Application for Two Variances, Each Subject to Four Conditions, Respecting One Third Party Electronic Ground Sign - 3003 Danforth Avenue

Date: October 29, 2025

From: Project Director, Business Transformation and Citywide Priorities, Toronto Building

Figure 1: Mock-up of Proposed Sign on the Subject Premises (from Submissions)

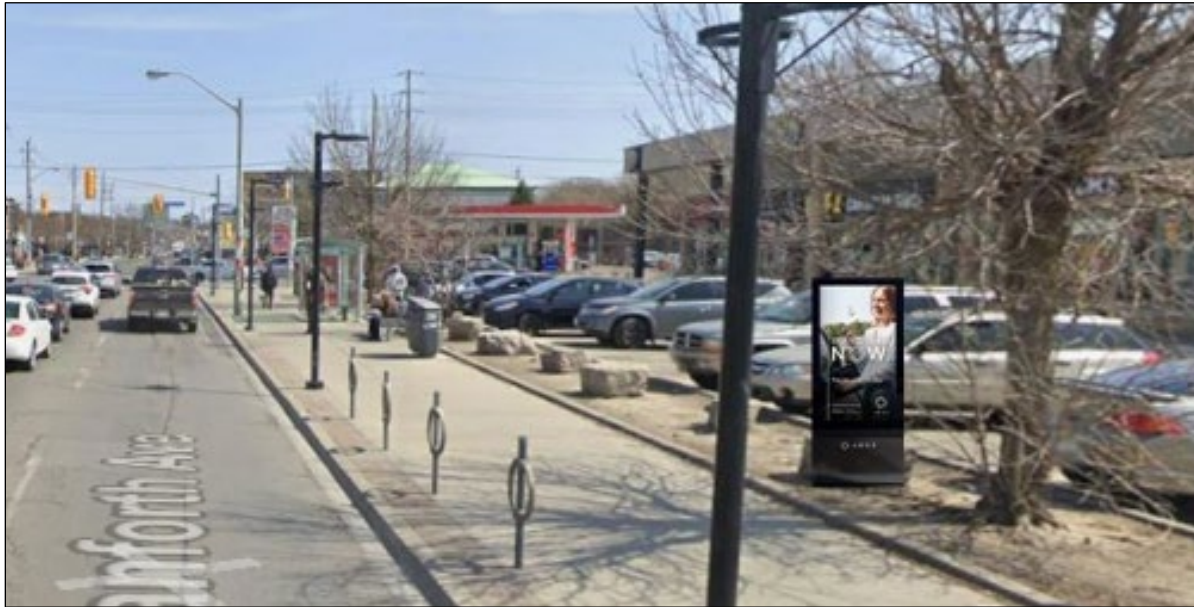
The Proposed Sign is an electronic ground sign with two sign faces displaying electronic static copy. The Proposed Sign would be located at the property municipally known as 3003 Danforth Avenue near the northerly frontage of the Subject Premises. It would consist of two rectangular sign faces in a back-to-back configuration, each with a

bisecting line measuring 0.93 metres (horizontal dimension) and centre line measuring 1.65 metres (vertical dimension), with a sign face area not exceeding 1.54 square metres. The sign faces would be oriented approximately east and west, targeting commuters on Danforth Avenue travelling in both directions. The Proposed Sign is described further in Attachment 1.

Figure 4: Map 22 Land Use Plan – 3003 Danforth Avenue

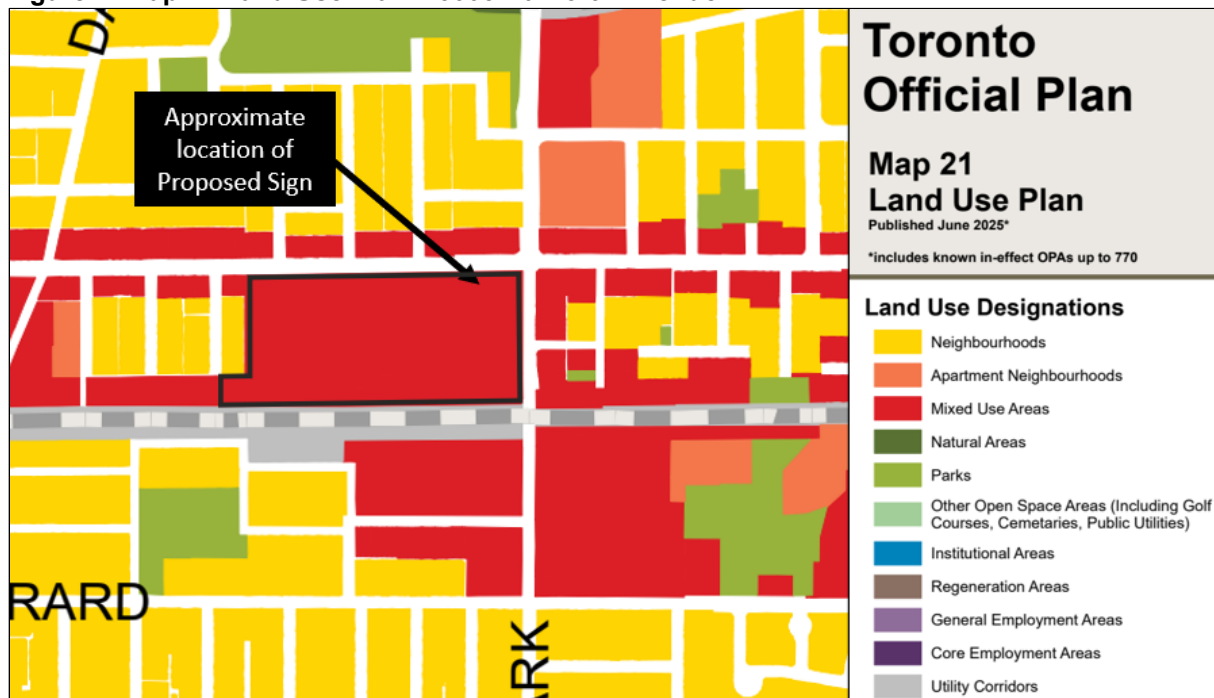
The Official Plan land use designation for the property at 3003 Danforth Avenue and surrounding lands to the north, east and west is mainly Mixed Use (see Figure 4). Mixed Use Areas are intended to promote a balanced and dynamic community by accommodating diverse needs through a combination of commercial, residential, institutional, and open space uses, similar to the uses currently identified on the area.

Submissions indicate that the Proposed Sign aligns with Sections 2.2.2, 2.3.1, 3.1.1, 3.4, and 4.5.2 of the Official Plan and Urban Design Guidelines as it: enhances the public realm by being contextually appropriate - modest in size and scale - and placed in underutilized lawn space to avoid interference with pedestrian flow; respects neighbourhood character through context-sensitive design; supports economic vitality by providing advertising space for local businesses and events; and mitigates land use conflicts, with no adverse effects on adjacent uses, including nearby open space.

Figure 5: Danforth Avenue (Coxwell to Victoria Park) Urban Design Guidelines Study Area Map

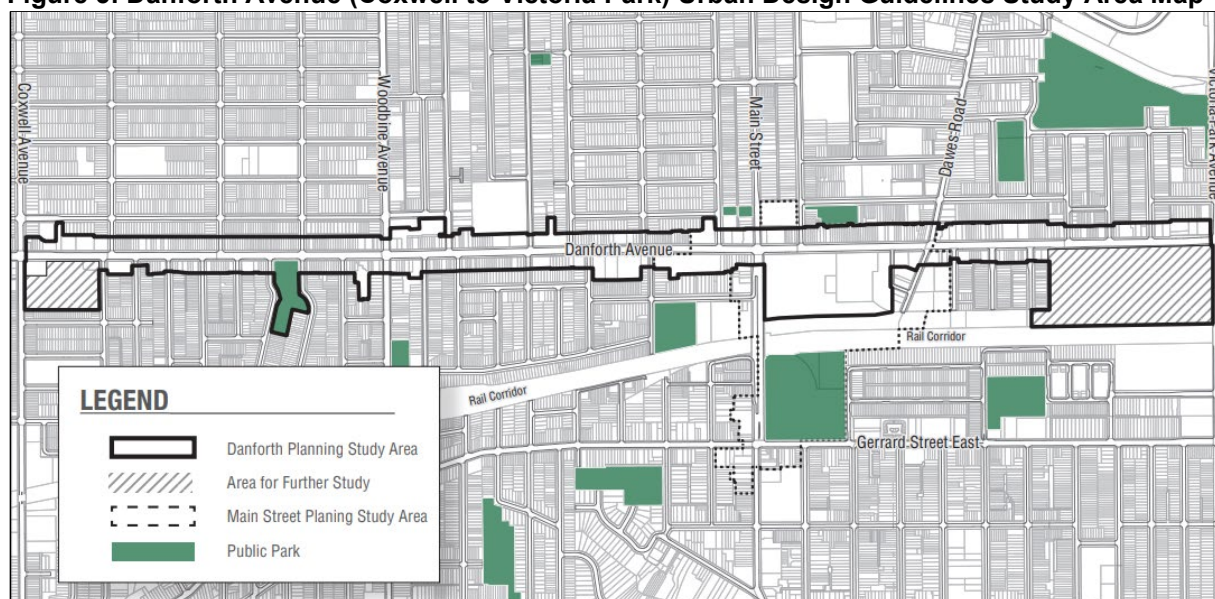
Staff has identified that the Subject Premises falls within the area governed by Site and Area Specific Policy 552 (SASP 552). The policy envisions balanced residential and non-residential growth in a mid-rise, mixed-use form that respects the existing main street character. It emphasizes the enhancement of the public realm through complete streets, wider sidewalks, active ground-floor uses, and investments in open spaces, parks, and POPS. As a designated transportation corridor and Focus Area, Danforth Avenue is intended to support safe, walkable, and cyclist-friendly environments, with particular attention to placemaking at the Danforth-Victoria Park Entry Node.

While the Proposed Sign may complement the existing commercial character, the submissions do not demonstrate how a non-permitted sign type aligns with the urban design guidelines and goals of SASP 552.

Figure 7: Dispersion of Light Diagram (from Submissions)

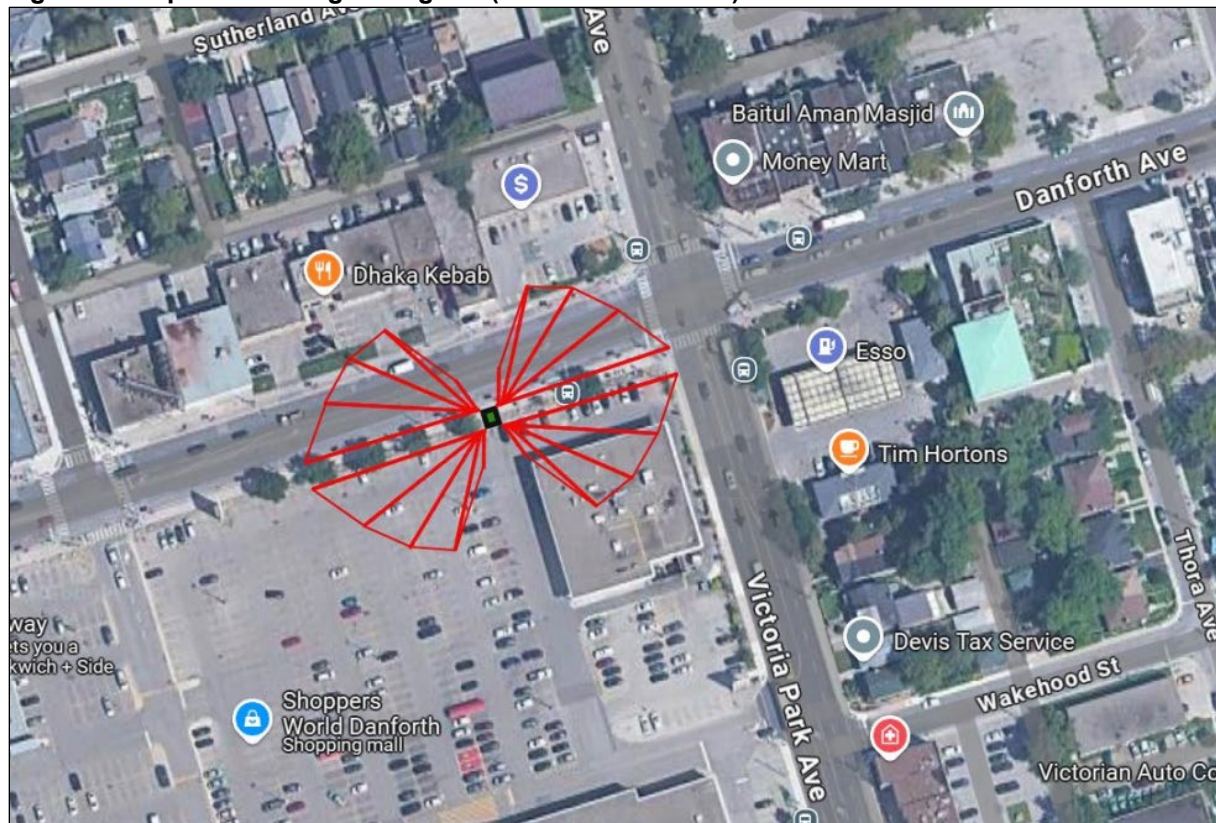
The Applicant contends that the east and west orientation of the Proposed Sign's sign faces ensures it does not directly face these residences. Furthermore, a light shed analysis submitted by the Applicant indicates that the electronic static displays,

operating at the maximum allowable brightness of 300 nits, would have a light reach of approximately 50 metres. Beyond this distance, the emitted light is said to be comparable to the brightness of a full moon, which the Applicant suggests is the threshold at which light becomes negligible.

The Applicant asserts that any amount of light outside the light shed cone represented in Figure 7 will be less than what a full moon emits, and as a result, there would be no light trespass into the existing residential properties along Victoria Park Avenue.

Staff agree that, based on the details provided in the submissions and subject to the 60-metre separation and maximum height conditions, the illumination impacts of the Proposed Sign on the nearby residences should be minimal.

Therefore, the CBO is of the opinion that the Applicant's submission materials have provided sufficient information to confirm that the Proposed Sign, subject to the specified conditions, should have no adverse effects on adjacent premises, and that this criterion has been established.

Figure 8: Location of Existing Signs in relation to the Proposed Sign

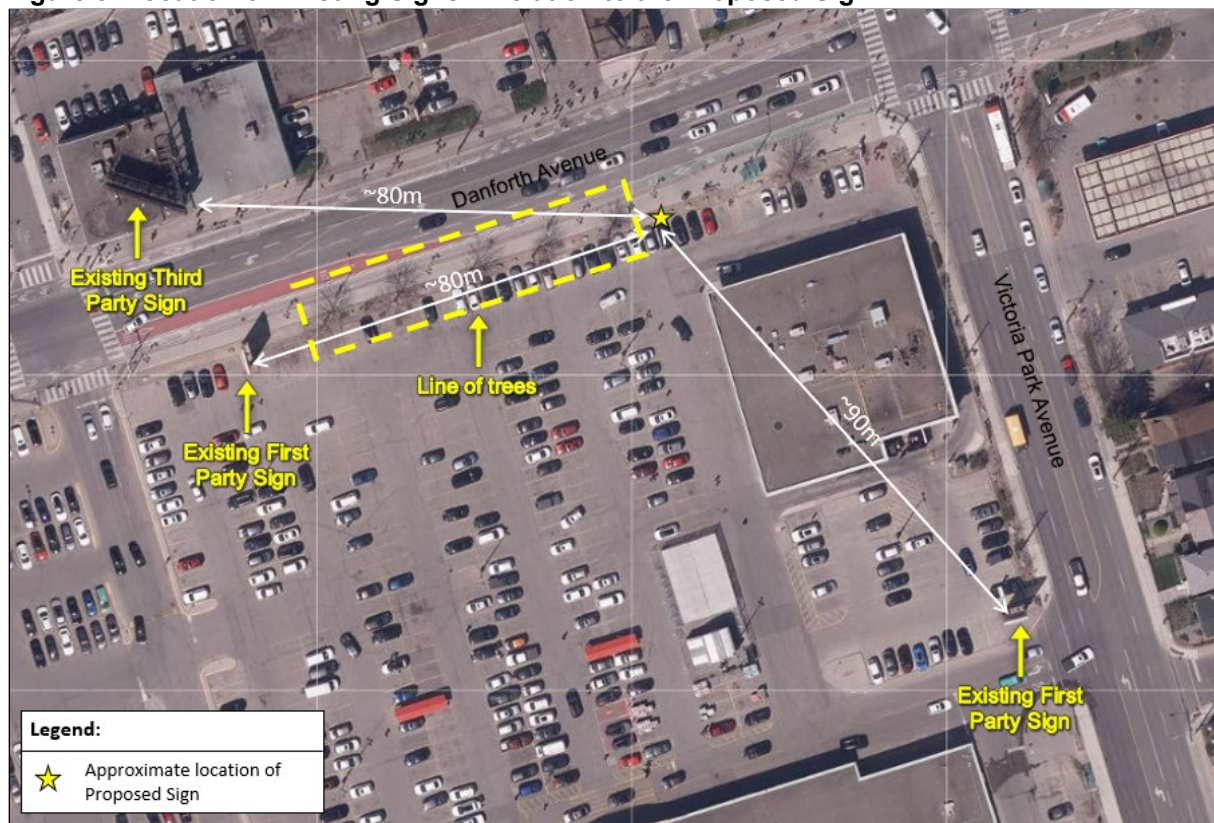
As mentioned previously, there are currently two first party ground signs displaying static copy on the Subject Premises, one on the north frontage, along Danforth Avenue and the one on the east, at Victoria Park frontage (see Figure 8). In Sign Districts where third party electronic ground signs are permitted, the Sign By-law mandates that such signs be the only ground sign on the Subject Premise, among other things, to avoid clutter. Although the Proposed Sign is not in a district where this sign type is permitted, the principle of minimizing clutter remains relevant.

Staff review has determined that the visual and spatial relationship between the Proposed Sign and the existing sign located on the east frontage of the Subject Premises is minimal. The two signs are oriented in different directions and are intended to serve distinct audiences. Additionally, the presence of an intervening building on the Subject Premises further obstructs sightlines, preventing simultaneous visibility of both signs.

Staff review has confirmed that the Proposed Sign would be located on the same frontage as one of the existing signs, approximately 82.0 metres to the west. Under the Sign By-law regulations applicable to CR Sign Districts, two first party ground signs are permitted on the same frontage provided the frontage exceeds 200 metres and the signs are separated by a minimum distance of 100 metres. The Subject Premises has a frontage of approximately 400 metres along Danforth Avenue, thereby meeting the criteria for accommodating two ground signs.

The Applicant asserts that the separation distance between the Proposed Sign and the existing first party ground sign, combined with the presence of large, mature trees along the Danforth frontage, provides sufficient visual buffering to mitigate concerns related to sign clutter. To maintain this visual separation, the Applicant has proposed the preservation of the existing trees on the Subject Premises. This preservation measure has been incorporated as a condition of approval should the requested variance be granted.

The CBO's opinion that the Applicant's submissions sufficiently demonstrate that the Proposed Sign would not alter the character of the Subject Premises or surrounding area, and this criterion has been established.
